Philips Healthcare

2024-CC-SRC-013

TGA Reference #:	RC-2024-RN-00850-1
Product / Device Name / Model #	Trilogy Evo, Trilogy Evo O2, and Trilogy EV300
ARTG Ref #	332200, 336800
Short Description	Flow Sensor Nebulised Aerosol Deposition

Urgent Product Defect Correction

Figure 1: Acceptable In-Line Nebuliser Placement.

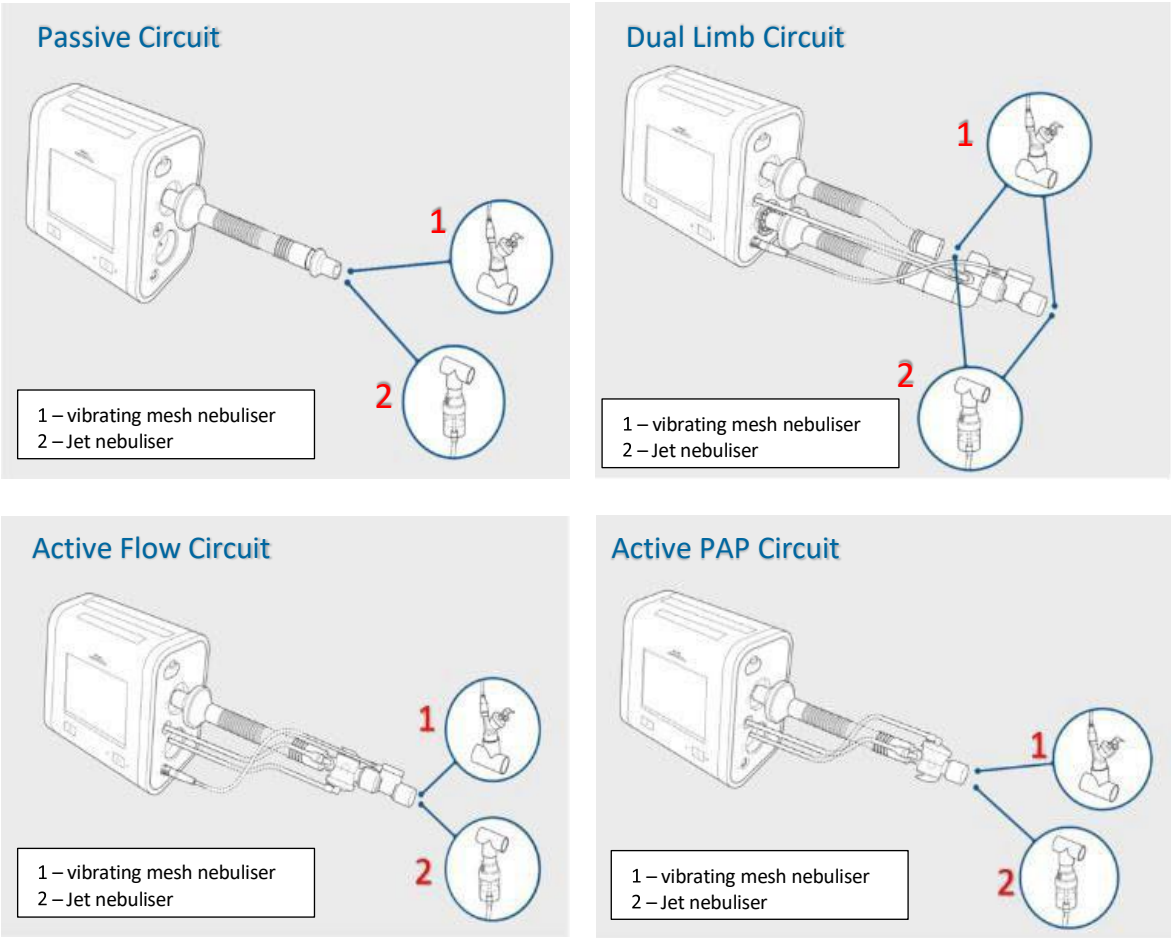
Circumstances that may result in aerosol deposition:

- When the in-line nebuliser is used with passive circuits for tidal volumes greater than or equal to 700 mL, or
- When the in-line nebuliser is placed at the dry side of the heated humidifier, or
- When the in-line nebuliser is placed at the “inspiratory port (to patient)” or (device outlet), or
- When the in-line nebuliser is placed in any location *other than* those identified in the images in Section 4

- If using in-line nebuliser treatments:
 - The circuit must be configured as pictured in the images in **Figure 1** below
 - For prescriptions needing tidal volumes greater than 700 mL with a passive circuit, transition patient to alternate circuit (Active PAP, Active Flow, or Dual Limb).
